Product Change Notice

Issue Date: 03-December-2021

Change of packing location

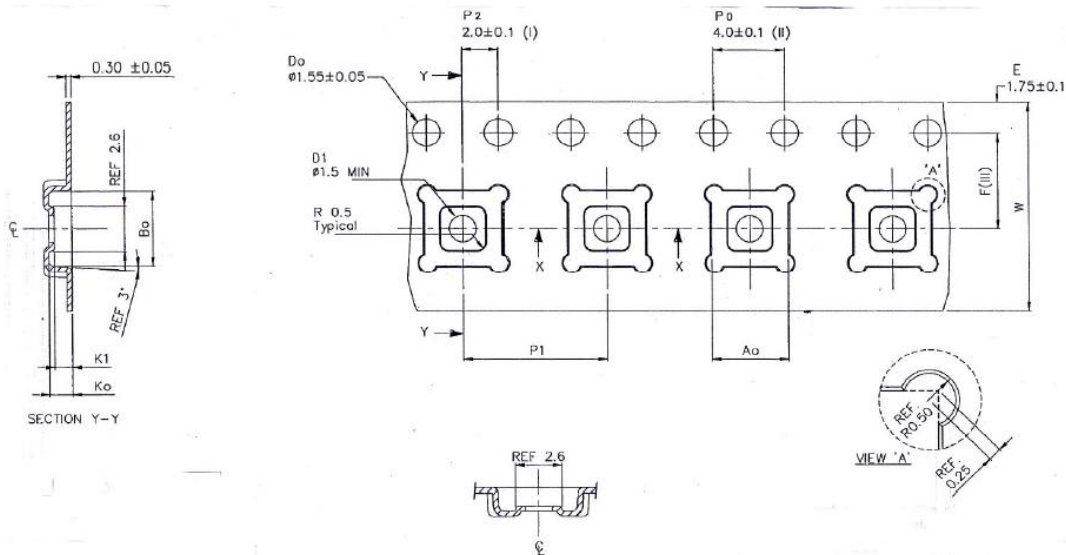
Change of packing location from UK to Germany. Minor changes in the reel-dimensions, for details refer to the following drawings (all dimensions in mm).

Current:

DIMENSIONS	
Ao	4,35 ±0,10
Bo	4,35 ±0,10
Ko	1,10 ±0,10
P	8,00 ±0,10
T	0,30 ±0,05
W	12,00 +0,30/-0,10

New:

A_0	=	$4,30 \pm 0,10$	K_1	=	$1,00 \pm 0,10$
B_0	=	$4,30 \pm 0,10$			
K_0	=	$1,30 \pm 0,10$			
P_1	=	$8,00 \pm 0,10$			
W	=	$12,00 \pm 0,30$			
t	=	$0,30 \pm 0,05$
